State of California
AIR RESOURCES BOARD

SPECIFICATIONS FOR FILL PIPES AND OPENINGS OF
MOTOR VEHICLE FUEL TANKS

Adopted: March 19, 1976
Amended: August 5, 1976
Amended: June 8, 1977
Amended: December 7, 1990
Amended: January 22, 1990
Amended: Insert date here

Note: Proposed amendments to this document are shown in underline to indicate additions and strikeouts to indicate deletions compared to the test procedures as last amended in January 22, 1990. Existing intervening text that is not amended is indicated by a row of asterisks (***).

FIGURE 1 : SAE J1114 TYPE FILL PIPE
(NORMAL RESTING POSITION)

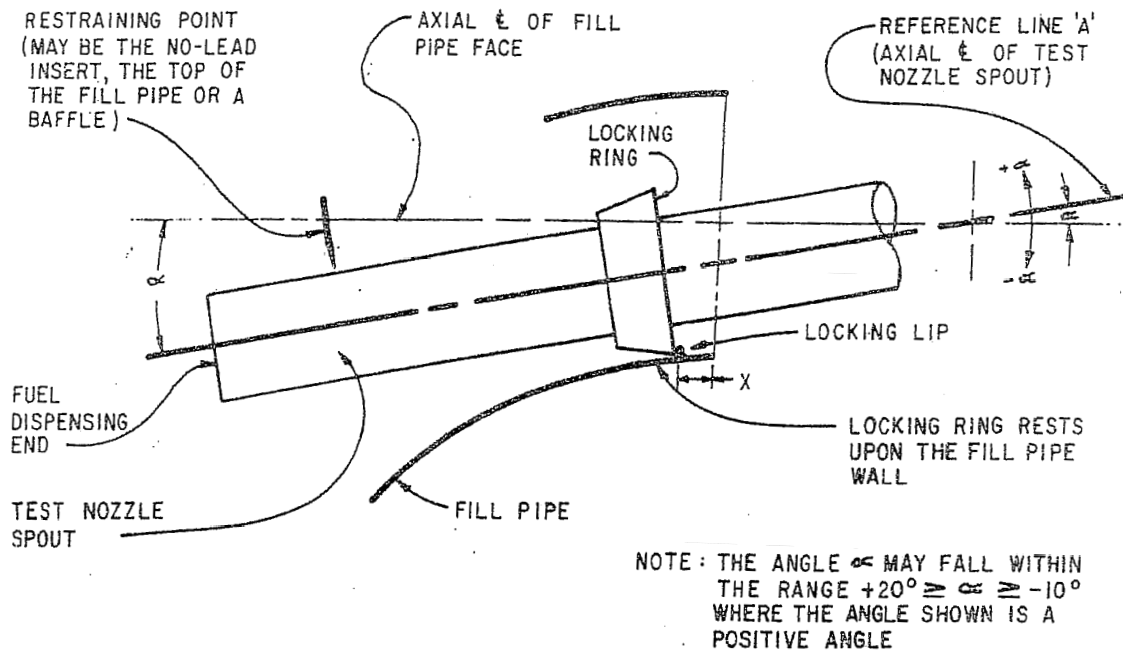
~~_____ 3. either the locking ring of the test nozzle spout rests upon the fill pipe wall, or the test nozzle spout shaft rests upon the locking lip as shown in Figures 1 and 2 respectively; and~~

~~_____ 4. the fuel dispensing end of the test nozzle spout (which is indicated in Figures 1 and 2) is in contact with a restraining point.~~

~~The normal resting position of the test nozzle spout is illustrated in Figures 1 and 2.~~

~~_____ G. “Angle Alpha” means the angle between the axial centerline of the test nozzle spout when in its normal resting position, and the axial centerline of the fill pipe face. Alpha is considered a positive angle when the fuel dispensing end of the test~~

FIGURE 1a : SAE J1114 TYPE FILL PIPE
(UNLATCHED POSITION)

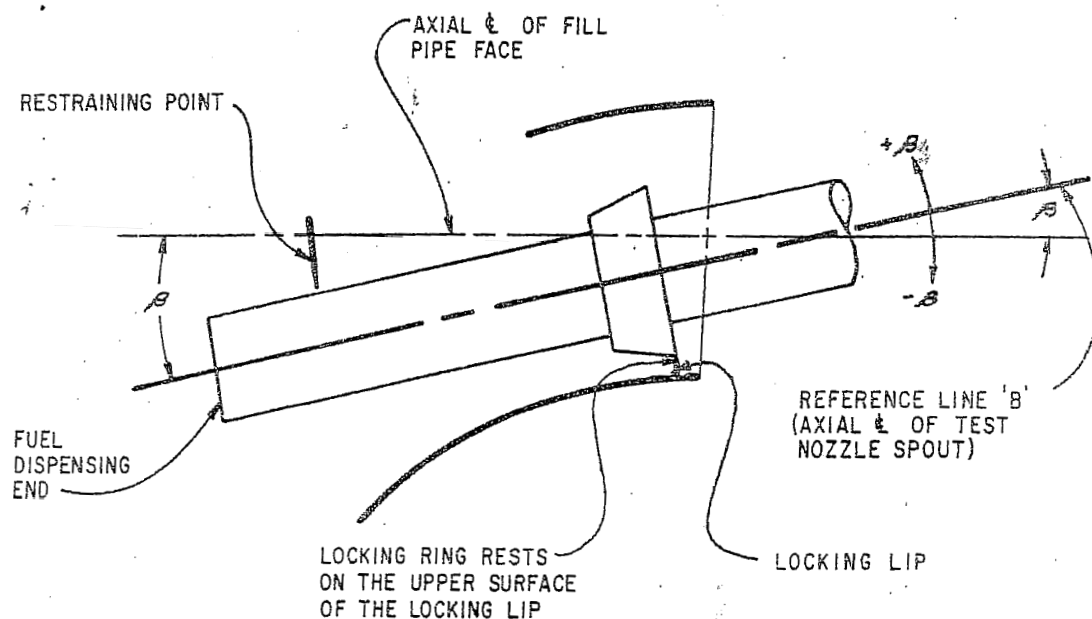
~~The unlatched position of the test nozzle spout is illustrated in Figures 1a and 2a.~~

~~H. “Angle Beta” means the angle between the axial centerline of the test nozzle spout when in its unlatched position, and the axial centerline of the fill pipe face. Beta is considered a positive angle when the fuel dispensing end of the test nozzle spout (which is indicated in Figures 1a and 2a) is pointing down relative to the axial centerline of the fill pipe face, as illustrated in Figures 1a and 2a.~~

FIGURE 2 : SAE J829B TYPE FILL PIPE
(NORMAL RESTING POSITION)

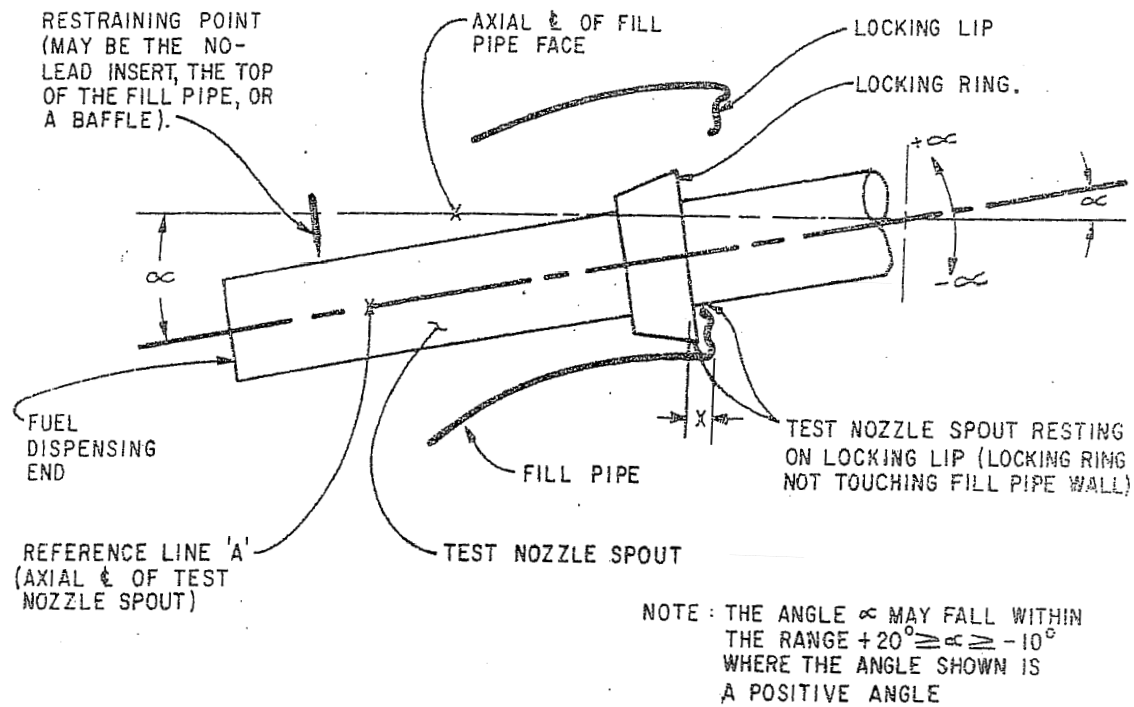
~~—— C. The internal portions of the fill pipe shall be configured such that test nozzle spout can be inserted far enough into the fill pipe to allow entrance of its locking ring beyond the fill pipe locking lip, and to allow deflection of the spout to the normal resting position and back to the unlatched position without binding. If the fill pipe contains a restriction device or other valve, it must be positioned so that the test nozzle spout in the normal resting position penetrates the restriction device or other valve by a minimum of 2.25 centimeters and allows free delivery of gasoline to the vehicle tank. The internal portions of the fill pipe shall also be configured to hold the test spout in its normal resting position such that the angle Alpha (α) falls within the range $20 \text{ degrees} \leq \alpha \leq 10 \text{ degrees}$ as shown in Figures 1 and 2.~~

Figure 3.

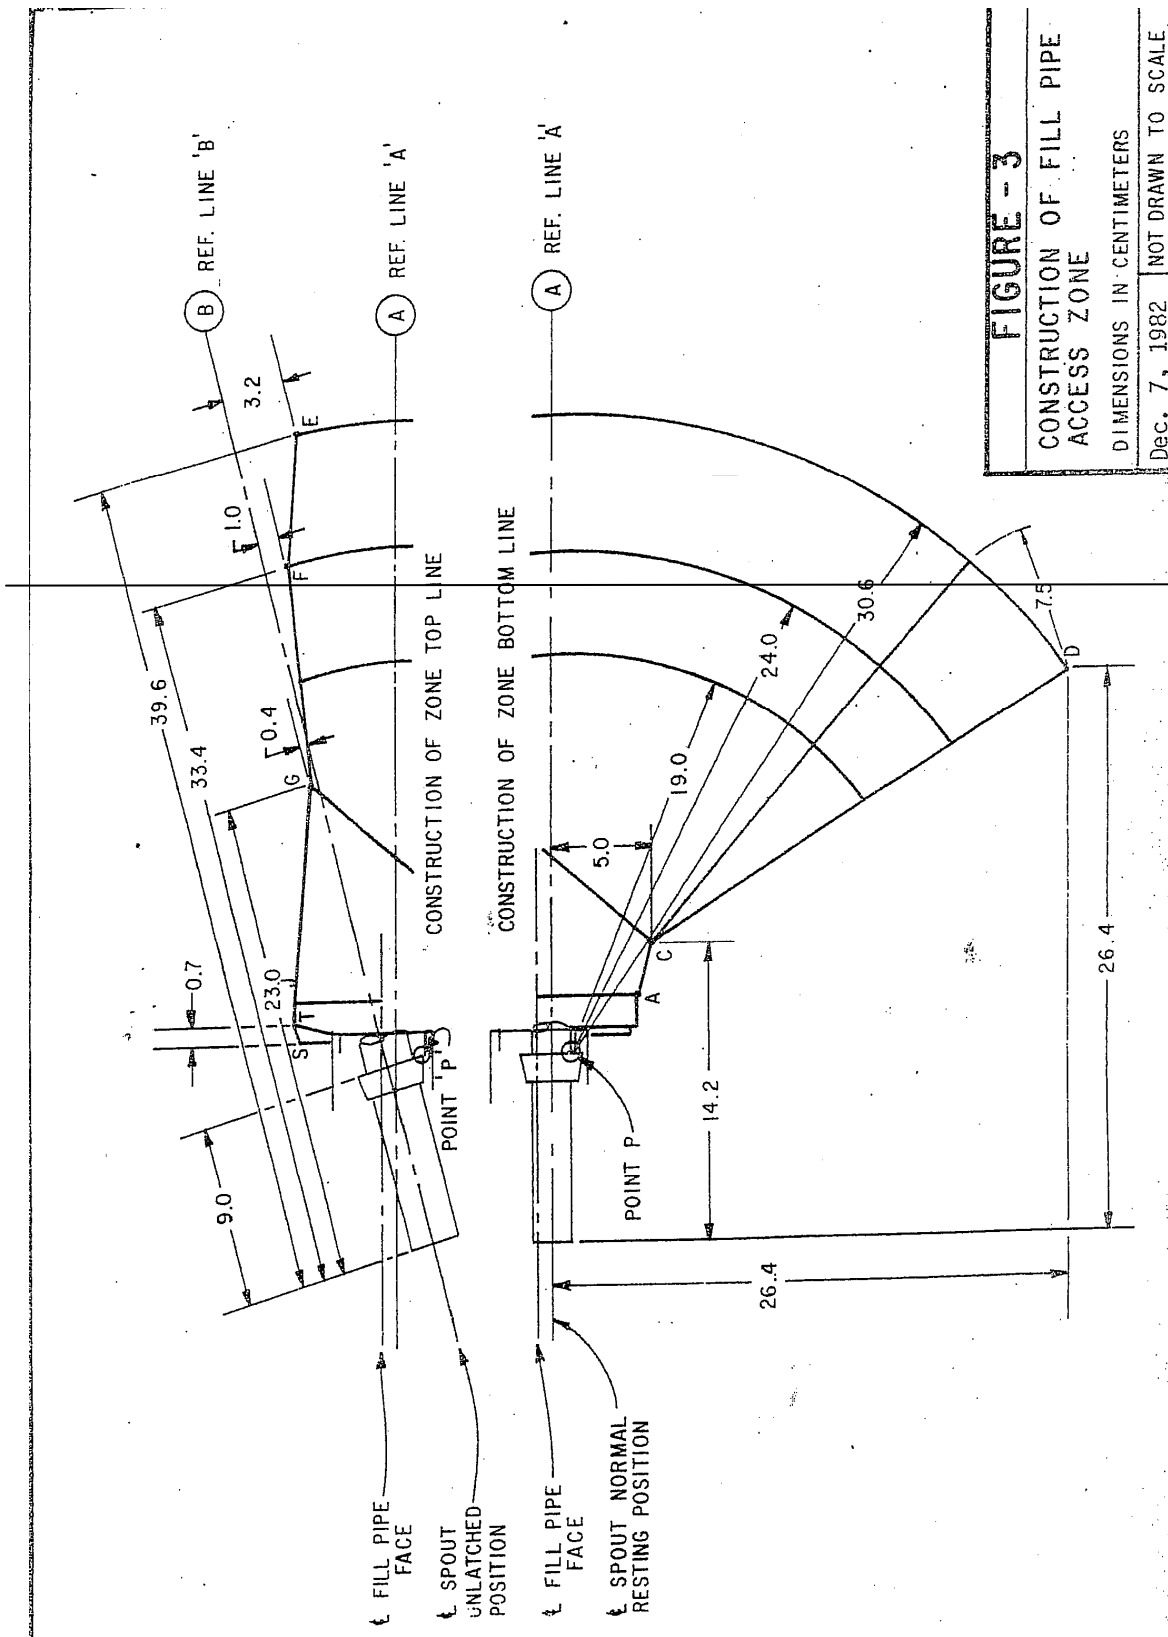
~~_____ C. “Fill pipe access zone” means the spatial zone in the vicinity of the fill pipe, as described by Figures 3 and 4, which is used for nozzle insertion, and which must be free of obstructions.~~

~~—— The fill pipe access zone shall be determined by first locating reference lines A and B, and Point D, E, and P. Point P, as shown in Figures 3 and 4, is located by finding the intersection point of 30.6 centimeters radius arcs struck from points D and E. Point P shall be the point from which the 19, 24, and 30.6 centimeter radii of the handle access zone (as indicated in Figures 3 and 4) as constructed. The fill pipe access zone is defined relative to reference lines A and B, as shown in Figures 3 and 4. Reference line A is the axial centerline of the test nozzle spout when it is in its normal resting position. Reference line B is the axial centerline of the test nozzle spout when it is in its unlatched position.~~
